**SUMMARY OF PMA
P050023/S087
BUNDLED WITH P950037/S151, P980023/S072, P070008/S063 AND P000009/S063
ProMRI FULL BODY SCAN (FBS) ICD SYSTEM
BIOTRONIK**

DESCRIPTION OF CHANGES/ REASON FOR SUPPLEMENT

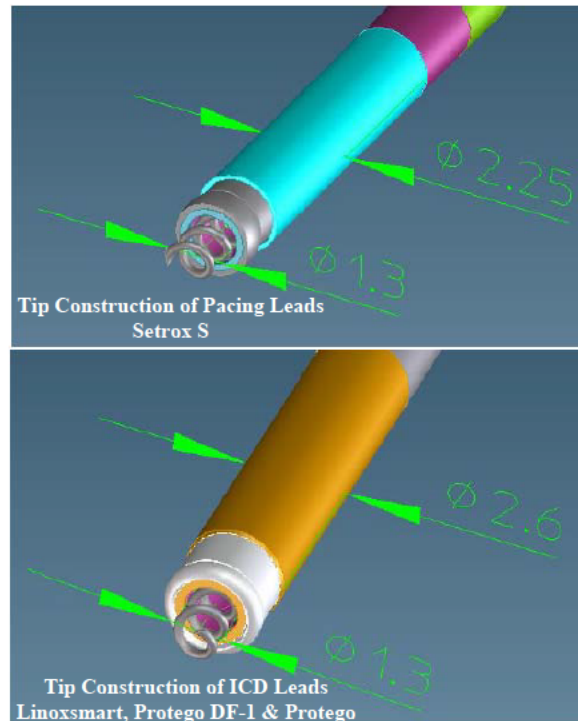
Even though the helix is identical (see figure 3), the tip diameter is not. A larger or smaller diameter of the tip in the immediate vicinity of the helix potentially impacts the ability to dissipate thermal energy into the surrounding tissue. It is not clear if this change will increase or decrease the tissue temperature and therefore the potential degree of damage to the tissue near the helix. The firm should provide some data, maybe

temperature profiles obtained from simulations, to show that the nearly 15 percent change in diameter has no substantial impact on the temperature rise near the helix. This is important since the ICD leads seem to be depositing higher amounts of power than the Setrox S 53 lead. The reviewers concern was expressed in Deficiency 1 of FDA's Major Deficiency Letter dated July 15, 2015:
